Project No. 10-1938

**RE: ADDENDUM TO GEOTECHNICAL INVESTIGATION AND LANDSLIDE HAZARD STUDY
LUETHE PARTITION LOT 2
SECTION 32 2N 1W TAX LOT 800
MULTNOMAH COUNTY, OREGON**

This letter is an addendum to GeoPacific's Geotechnical Investigation and Landslide Hazard Study report, dated March 17, 2010, and should be considered in conjunction with the report. The attached revision of Figure 2 completely replaces the original Figure 2. The purpose of this addendum is to present GeoPacific's assessment of potential impacts on slope stability posed by the construction and use of on-site septic system serving the proposed single-family home.

FIGURE 2

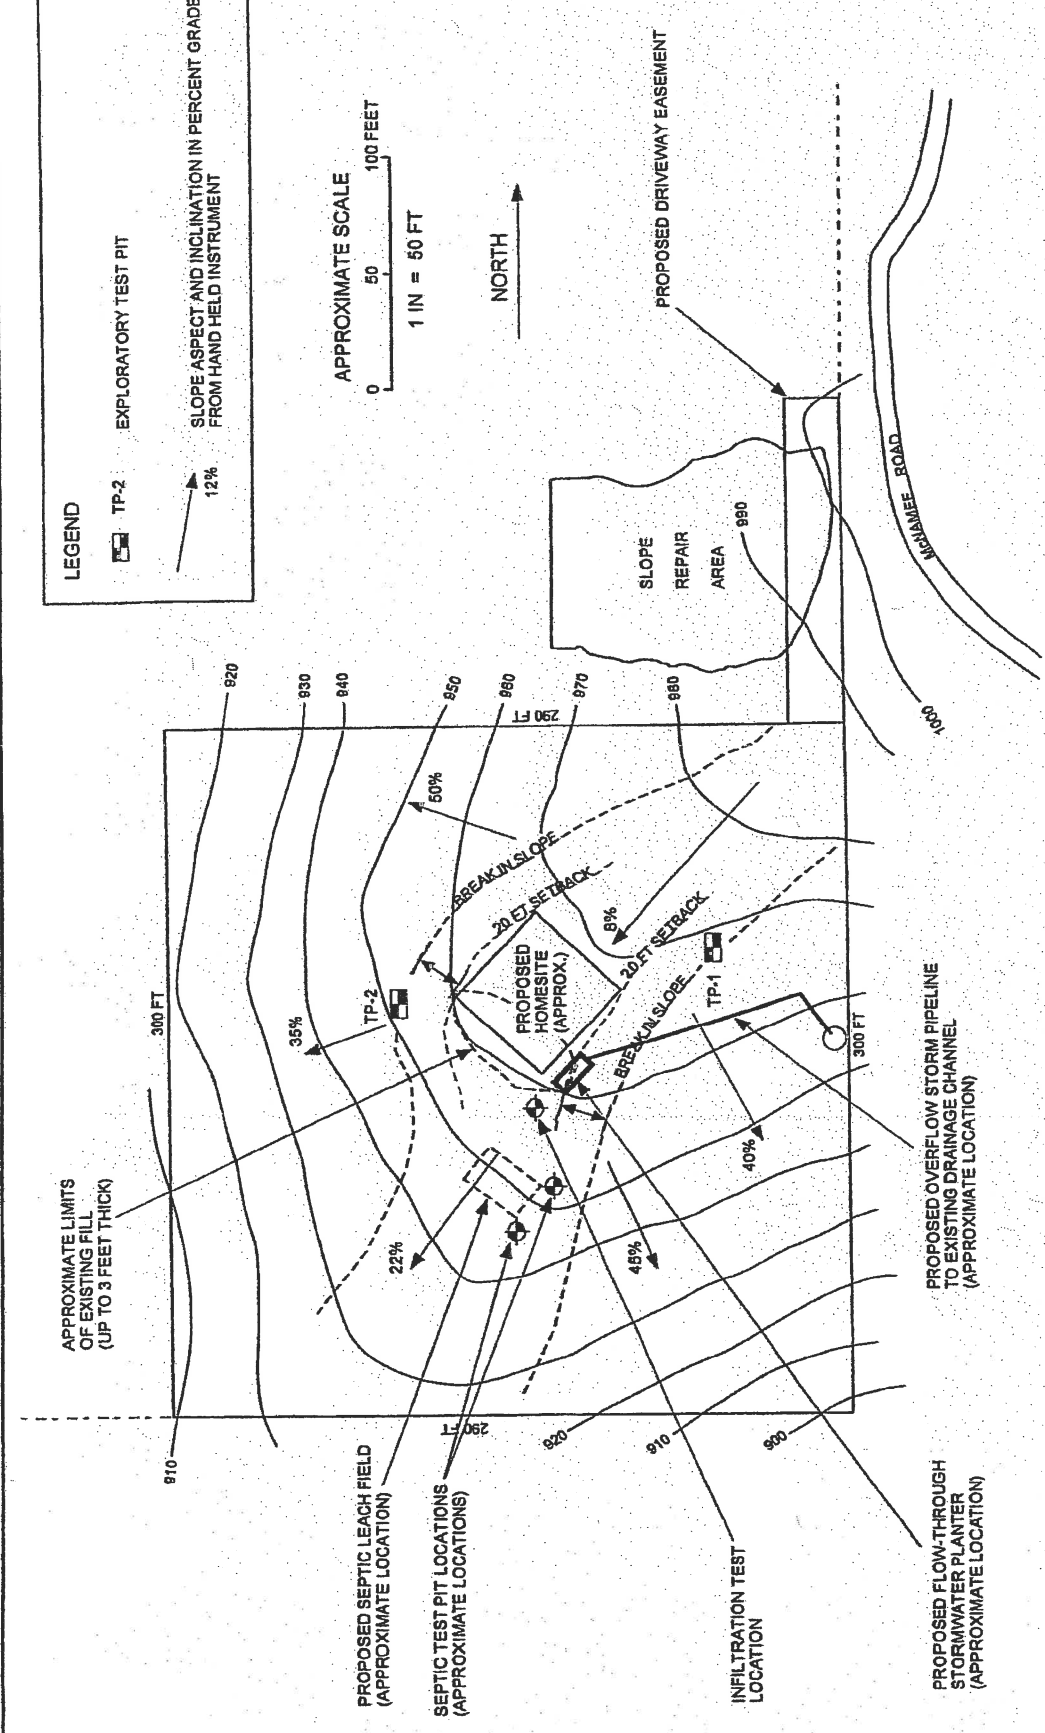
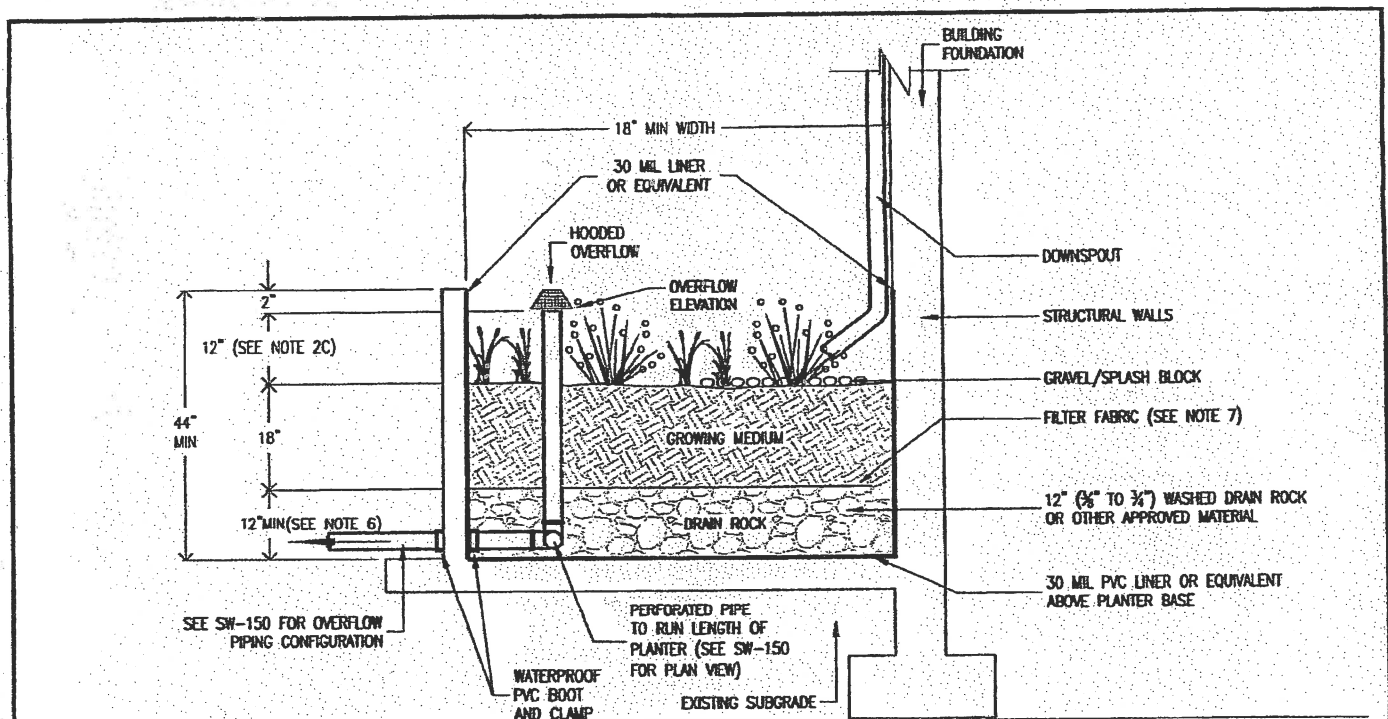
It is our understanding that a septic leach field is proposed on the slope south of the proposed homesite at the approximate location shown in Figure 2 (attached). We further understand that geotechnical review of possible adverse effects that the system might pose to slope stability have been requested because the slope at the leach field location exceeds 20% grade.

On October 15, 2010, GeoPacific engineering geologist, Paul A. Crenna, visited the project site and reviewed slope conditions in the vicinity of the proposed leach field and stormwater facilities. Field measurements with a hand-held clinometer indicate that the slope at this location inclines at about 22% grade. Slope geomorphology is smooth and uniform consistent with relatively stable slope conditions, and no evidence of prior slope instability was observed on slopes immediately below the proposed leach field.

In our opinion, the proposed septic leach field has a low potential for adverse effects on slope stability; however, due to space conflicts with the planned on-site stormwater infiltration system, we recommend that the stormwater management plan for the homesite be modified. We recommend that roof runoff be discharged to a stormwater flow-through planter constructed in accordance with the standard City of Portland detail (attached) with the overflow outlet discharging to the natural drainage along the eastern property line as shown in Figure 2. We anticipate that the pipeline can be installed in a shallow hand dug trench in accordance with the International Plumbing Code.
